WESTWOOD HILLS 2ND ADDITION

Re: S/D 98-57 -- One-Step Final Plat of WESTWOOD HILLS 2ND ADDITION

STAFF REPORT
(One-Step Final Plat-Approved 5/21/98)

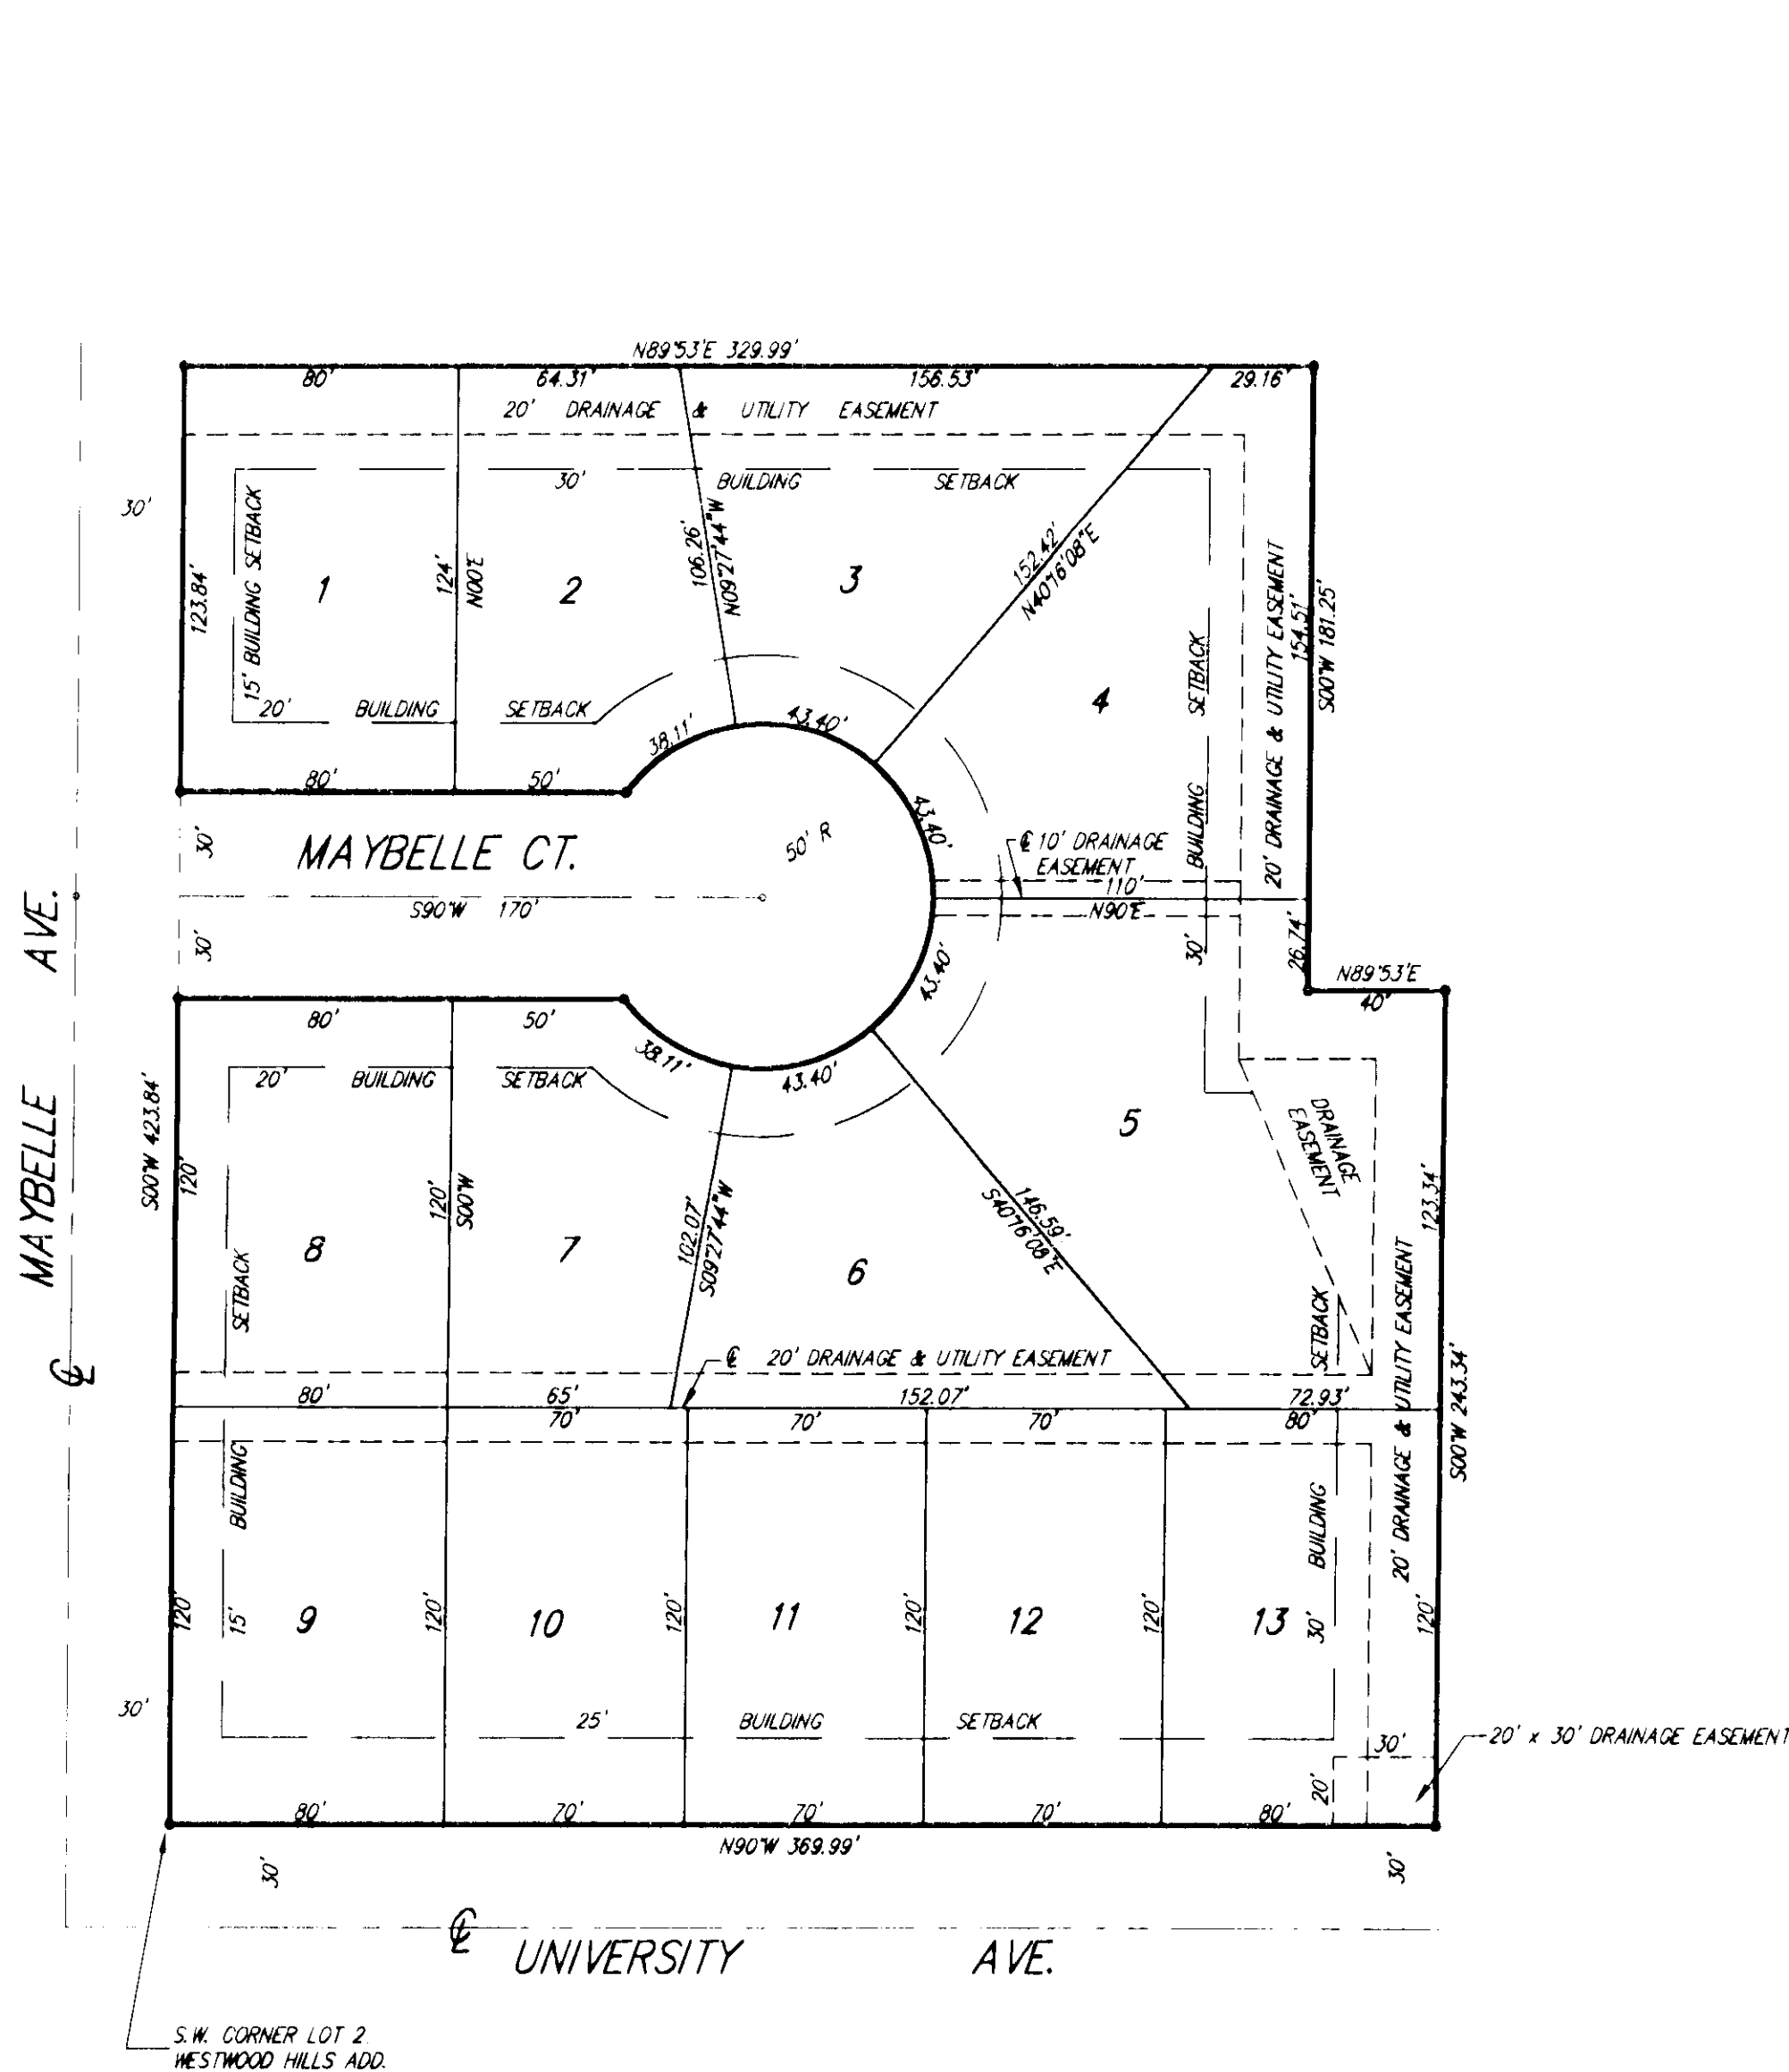
- A. City Engineering needs to indicate if any guarantees are required. Guarantees are required for the extension of water and sewer to serve the lots.

- C. City Engineering needs to comment on the status of the applicant's drainage plan. The drainage plan is approved. Drainage easement shall be denoted to cover the proposed storm sewer. A storm sewer guarantee will be required.

- D. The applicant shall guarantee the paving of the proposed interior street.
- E. The final plat tracing shall reference a tie point from a section corner and its distance to the plat.

- F. The perimeter of the plat does not coincide with the perimeter of Parcel 4 of the CUP and an administrative adjustment needs to be completed. In addition, the plat does not conform with the 50-foot setback imposed by the CUP along Maybelle and University Avenue (15-foot and 20-foot platted setback). MAPD recommends maintaining the standard 25-foot front yard setback along

University Avenue. An administrative adjustment needs to be completed for this setback revision.

- G. Traffic Engineering needs to comment on the need for any improvements to University Avenue and Maybelle Avenue. *No improvements are needed.*
- H. The applicant shall submit a covenant which provides for four (4) off-street parking spaces per all dwelling units in the plat. The covenant shall inventory the affected lots by lot and block number and shall state that the covenant runs with the land and is binding on future owners and assigns.

- N. Perimeter closure computations shall be submitted with the final plat tracing.
- O. Recording of the plat within thirty (30) days after approval by the City Council and/or County Commission.
- P. The representatives from the utility companies should be prepared to comment on the need for any additional utility easements to be platted on this property.
- Q. The applicant is reminded that a disk shall be submitted with the final plat tracing to the Planning Department detailing this plat. This will be used by the City and County GIS Department.
